RE: RESPONSE TO INFORMATION REQUEST FOR TOWN PLANNING APPLICATION FOR:-

- A) MATERIAL CHANGE OF USE – IMPACT ASSESSMENT FOR UNDEFINED USE (WORKERS' ACCOMMODATION), TOURIST PARK AND CARETAKER'S ACCOMMODATION AND ASSOCIATED AND ANCILLARY FACILITIES IN TWO (2) STAGES; AND**
- B) OPERATIONAL WORK – IMPACT ASSESSMENT FOR ADVERTISING DEVICE (FREESTANDING SIGN)**

**ON LAND DESCRIBED AS PART OF LOT 2 ON RP745166 AND LOCATED AT LOT 2 CAPTAIN COOK HIGHWAY, PORT DOUGLAS
COUNCIL REF: CA 2025_5732
SARA REF: 2503-45404 SRA**

In this regard, we refer to Council's Information Request dated 3 April 2025 and Council's email dated 26 November 2025 providing an extension to the Applicant Response Period to 19 December 2025.

APPENDIX 3
SHEET 2
CREES CREEK CROSSING
AND SITE ACCESS PLAN
DECEMBER 2025

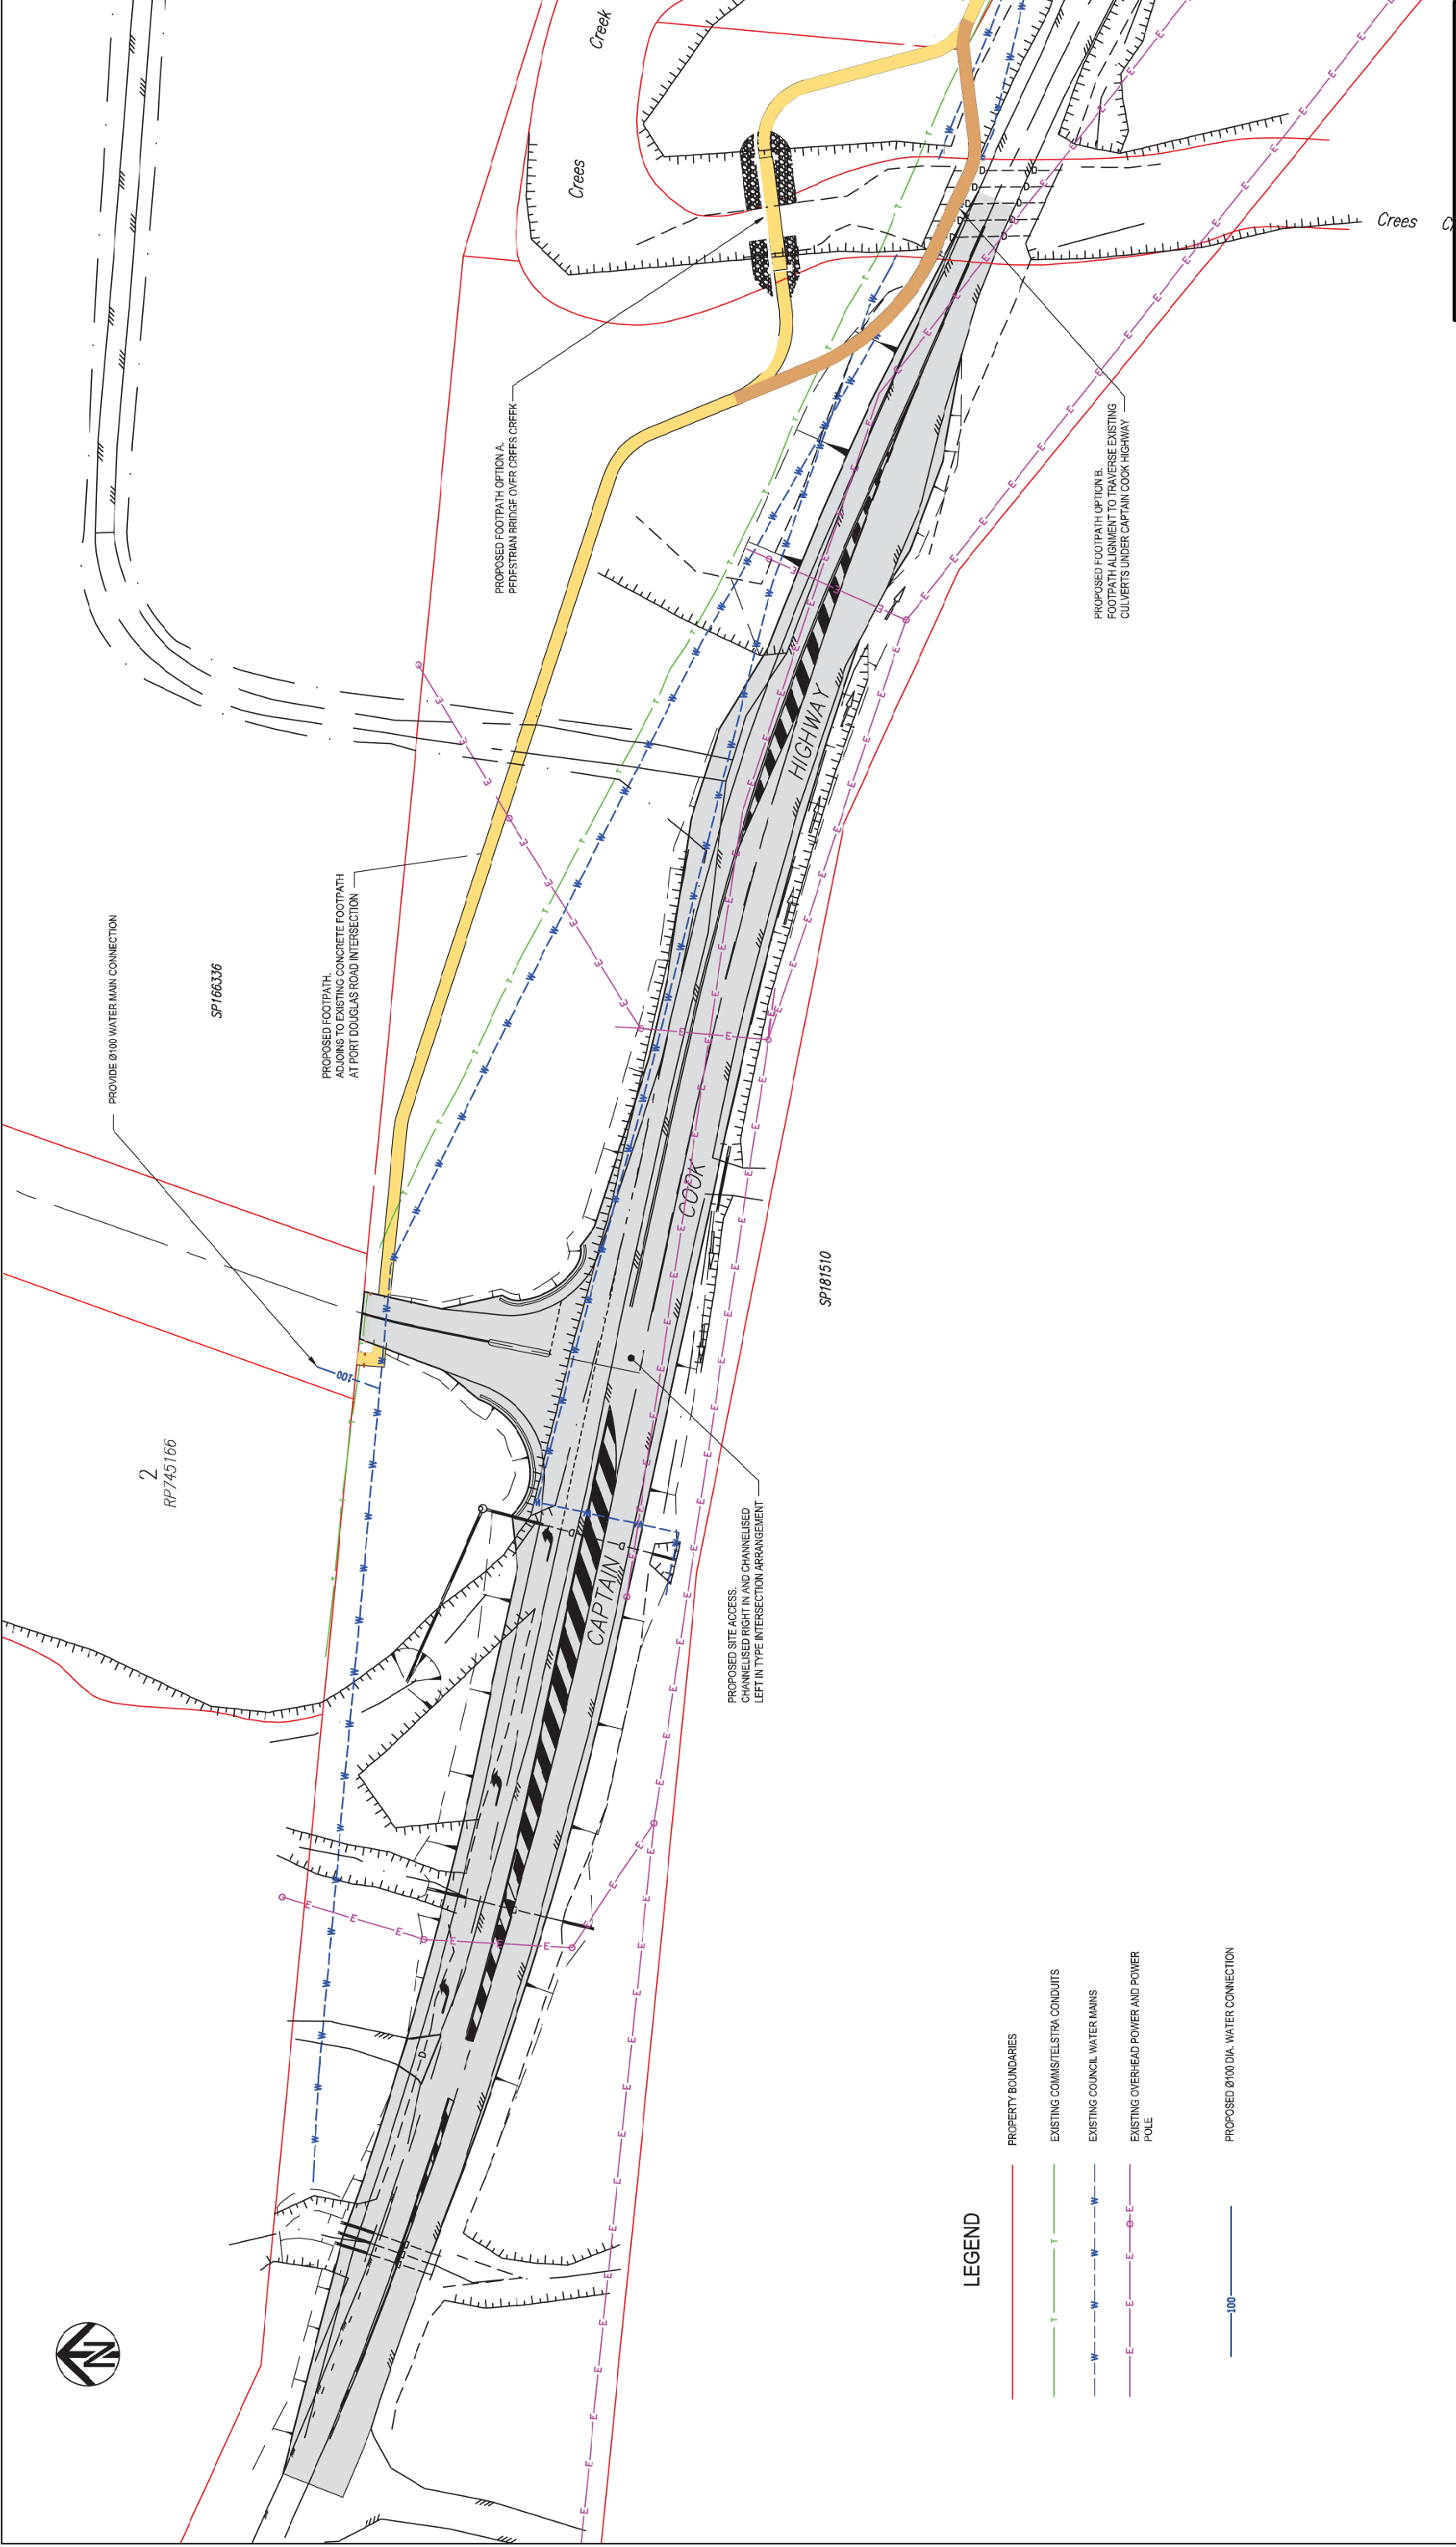
It is important that appropriate and safe pedestrian and bicycle connectivity accompany the development. In this instance, pedestrian and bicycle access needs to be provided to the intersection of the Captain Cook Highway and Port Douglas Road, where the local IGA Shopping complex is located. Without appropriate and safe pedestrian and bicycle connectivity the development is considered inconsistent with the Strategic Framework and the Planning Scheme Codes. The lack of suitable and safe pedestrian / bicycle connectivity is also considered to compromise the safety and functionality of the adjacent State-controlled Road.

*"The **attached** Drawings (Refer **Appendix 3**) shows the intended layout of the path to serve as the required pedestrian/cycle pathway. The plan shows two options, and we advise that option B is the preferred location.*

APPENDIX 4 - LANDSCAPE CONCEPT PLAN

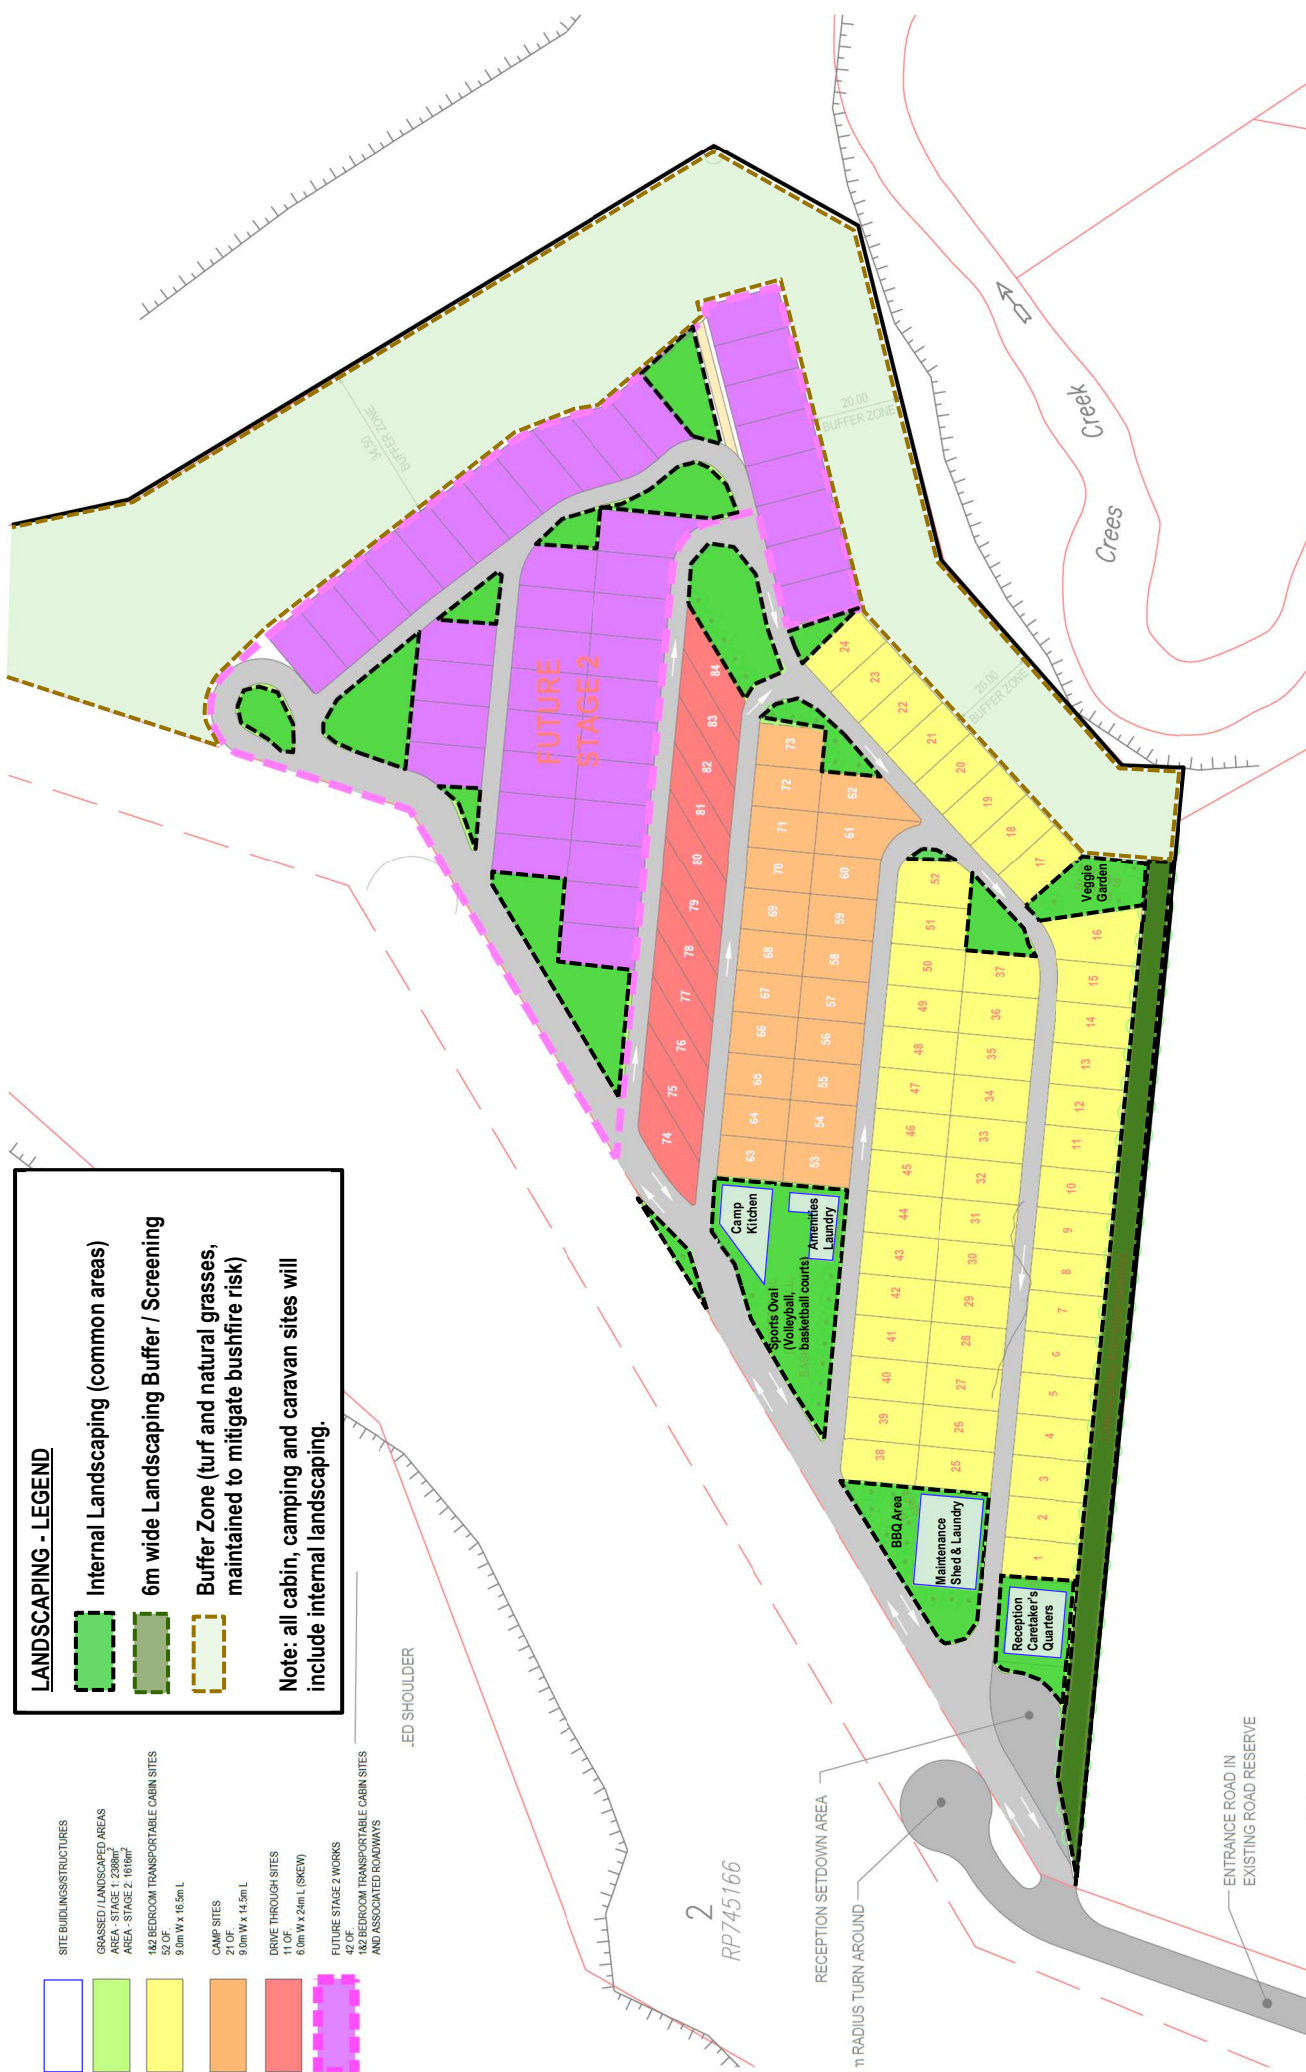
16. Please provide general scope of landscape design for the areas to be landscaped. The scope needs to nominate the areas to be landscaped, details (including height and width) of any mounding, the general range of species and anticipated height at commencement and after five years growth.”

The proposed extent and massing of on-site landscaping is shown by the Landscape Plan attached as **Appendix 4** and the proposed landscaping within the Cabins sites is shown by **Appendix 5**.

APPENDIX 5 – TYPICAL CABIN LAYOUT PLAN

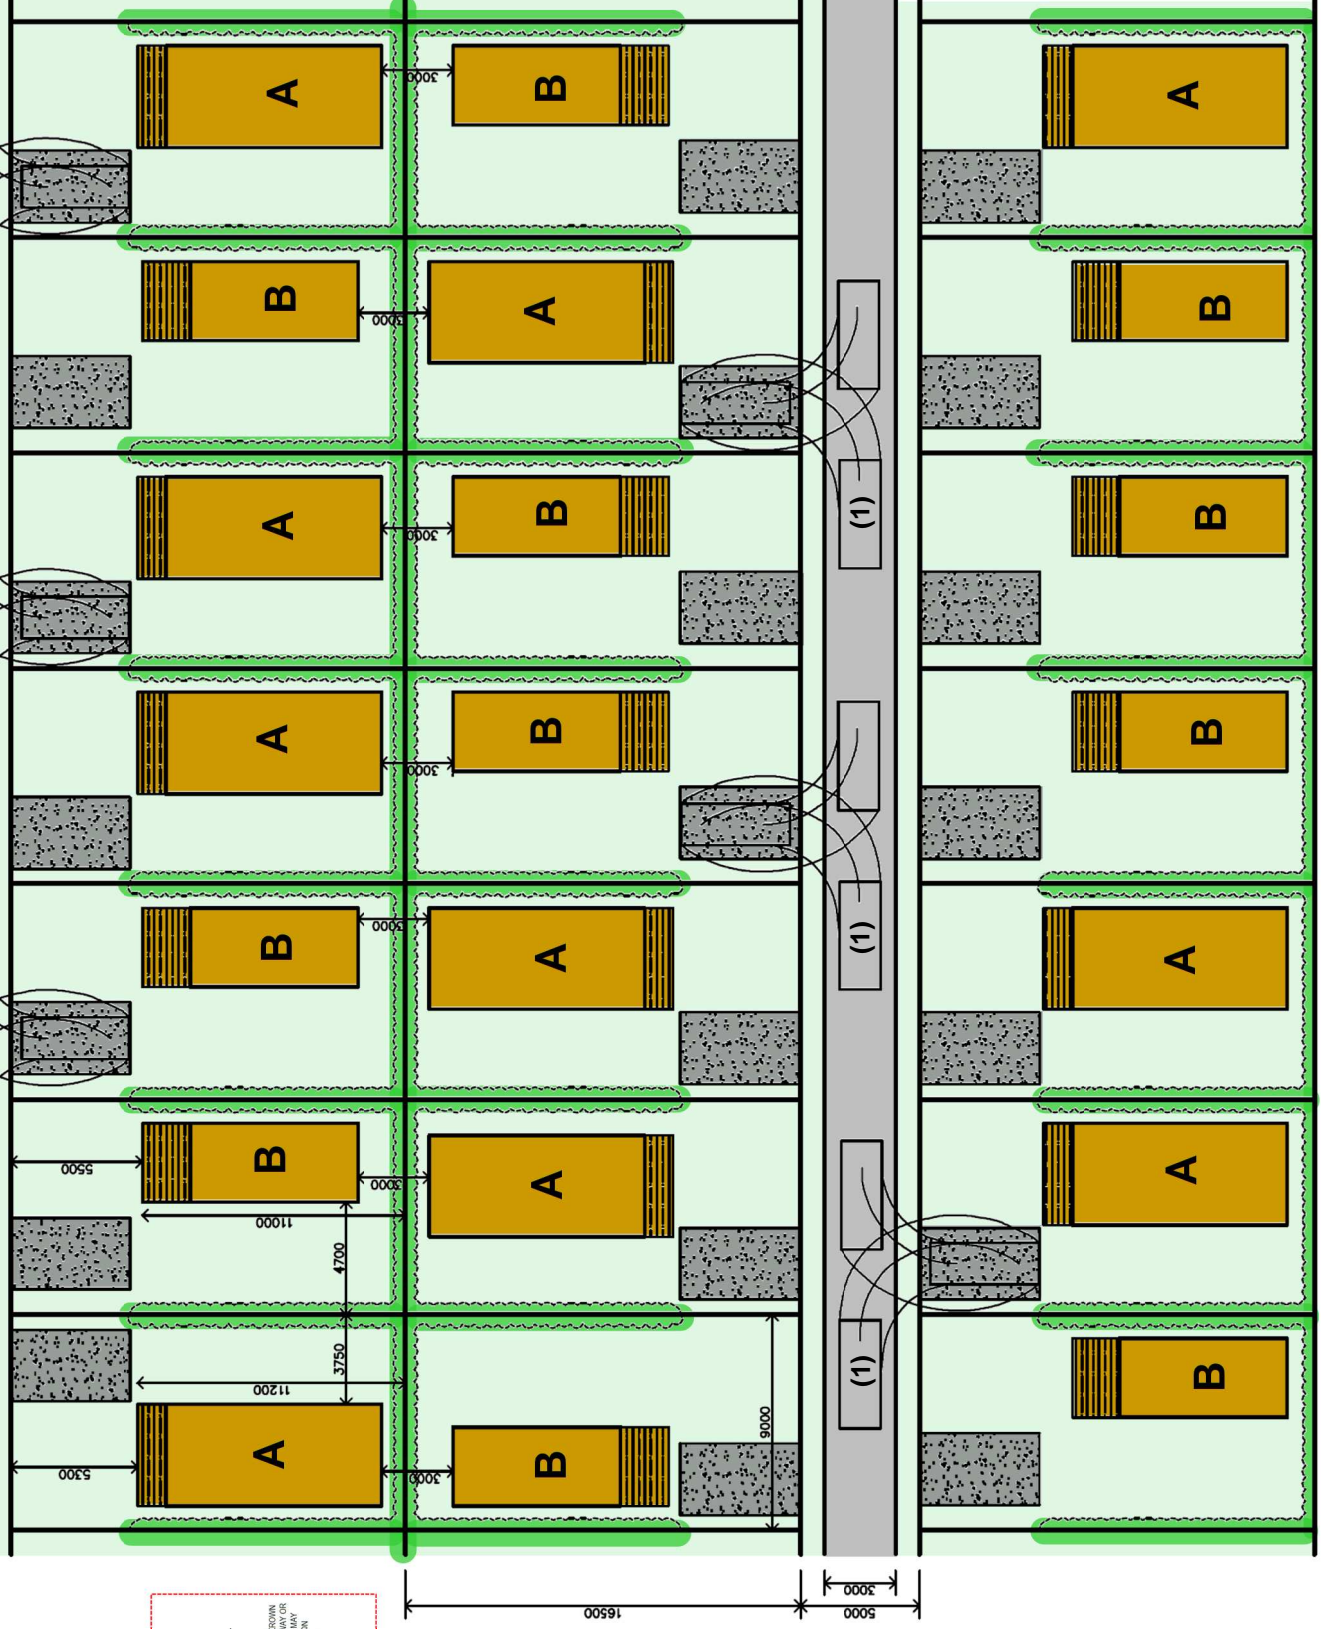
17. Please provide a typical layout for a group of cabins on the intended lot plan layout to clarify each is capable of providing a car parking space, sufficient private open space, sufficient setback from the internal road network and from other adjacent cabins etc.”
